UNITED STATES PATENT AND TRADEMARK OFFICE

| APPLICATION NO. | FILING DATE | FIRST NAMED INVENTOR | ATTORNEY DOCKET NO. | CONFIRMATION NO. |
|---------------------|-------------|----------------------|---------------------|------------------|
| 10/802,337 | 03/18/2004 | Michel Valentini | 251-IUS | 3748 |

| Office Action Summary | Application No. 10/802,337 | Applicant(s) VALENTINI, MICHEL | |

DETAILED ACTION

Sweers (US Patent Number 5555680) Figures 2 and 3

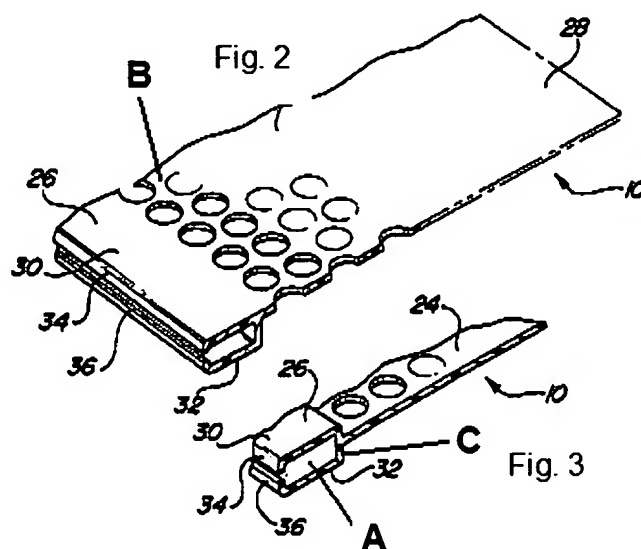
13. Sweers discloses in Figures 1 and 2 a gutter cover that has an elongated main section (24) with an outer side section (26). Additionally, he discloses perforations (B) in the main section (24). Sweers teaches that the outer side section has a channel (A) that opens away from the main section (24), which can fit over the lip (22) of a gutter. Sweers also discloses a gripping surface on the outer side section that extends upwardly, which is formed from the end wall (C) and top section (30) of the channel. The end wall (C) and upper edge (30) of the U-shaped channel inherently form a gripping surface, facing away from the channel opening, to pull the channel over the lip of a gutter. Regarding claim 8, Sweers discloses a channel defined by a top wall (30), bottom wall (32), and end wall (C) that join the top and bottom walls.

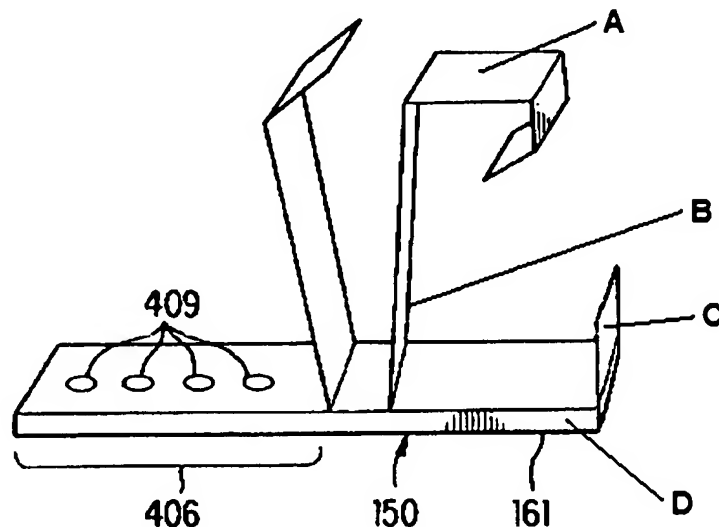
18. Claims 4, 5, 6, and 7 are rejected under 35 U.S.C. 103(a) as being unpatentable over Sweers in view of Hileman as applied to claim 3 above, and further in view of Albracht (US 6701674). Sweers in view of Hileman teaches everything previously disclosed, but fails to teach that the bottom wall of the channel is aligned with the panel and the surface of the end wall adjacent the panel forms the gripping surface (claim 4), that the bottom wall is shorter than the end wall (claim 5), and that the bottom wall has retaining means on its top surface near its outer free end (claims 6 and 7). Albracht, however, discloses in Figure 4B a gutter cover with a channel that is aligned with a panel (406) and the surface of the end wall (B) adjacent to the panel (406) forms the

gripping surface. Albracht also discloses a bottom wall (D) of the channel, that when measured, is shorter than the end wall (B), and the bottom wall has a restraining means (C) on its top surface near its outer free end. Therefore, it would have been obvious to one having ordinary skill in the art at the time of invention to further modify Sweers' gutter cover, already modified by Hileman, by making the bottom wall of the channel aligned with the panel, the bottom wall of the channel shorter than the end wall, and have retaining means on the top surface of the bottom wall near its outer free end, as taught by Albracht to easily and securely attach to the lip of an installed gutter.
